Response to Submissions LEP Amendments

Waterloo South

Response to Submission Summary

Proposed CSSDA **RtS** LEP Amendments - Active Frontages.

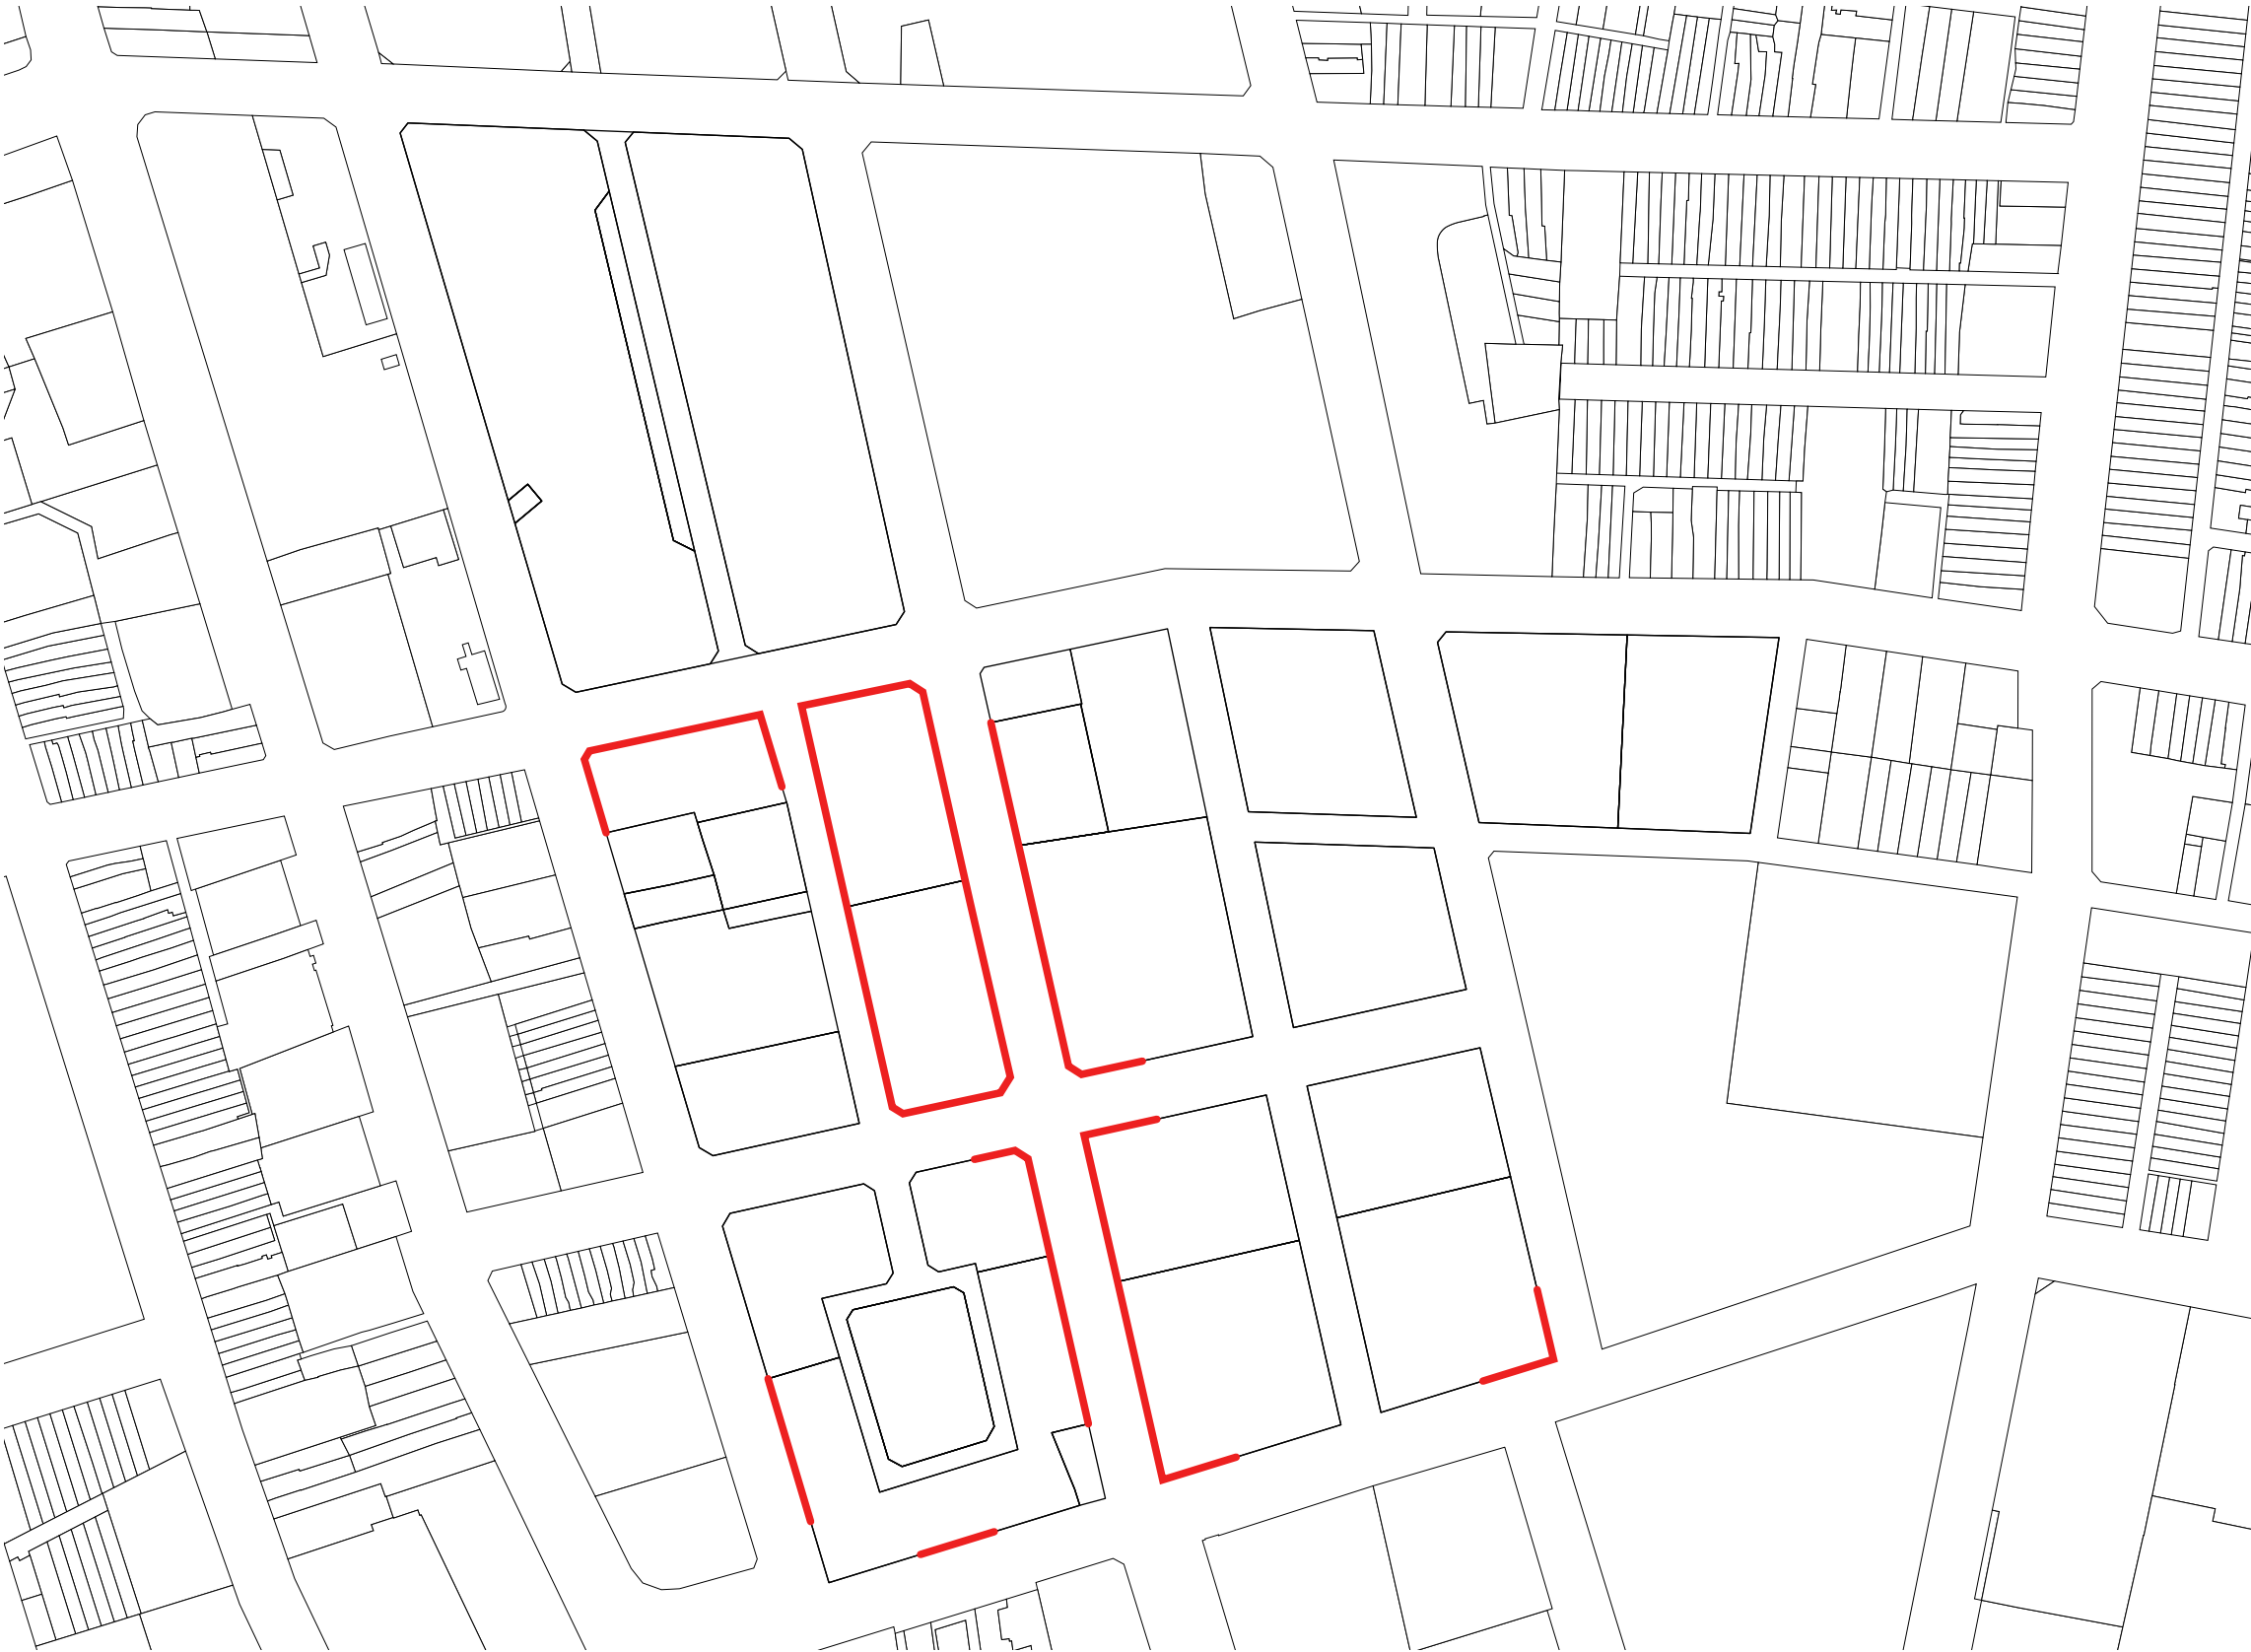
Stockland	<u>Active Frontages</u> Amend to align with Stage One design.	Active frontages along McEvoy Street on Blocks 8 & 9 amended to reflect Stage One treatment as confirmed by Stockland,
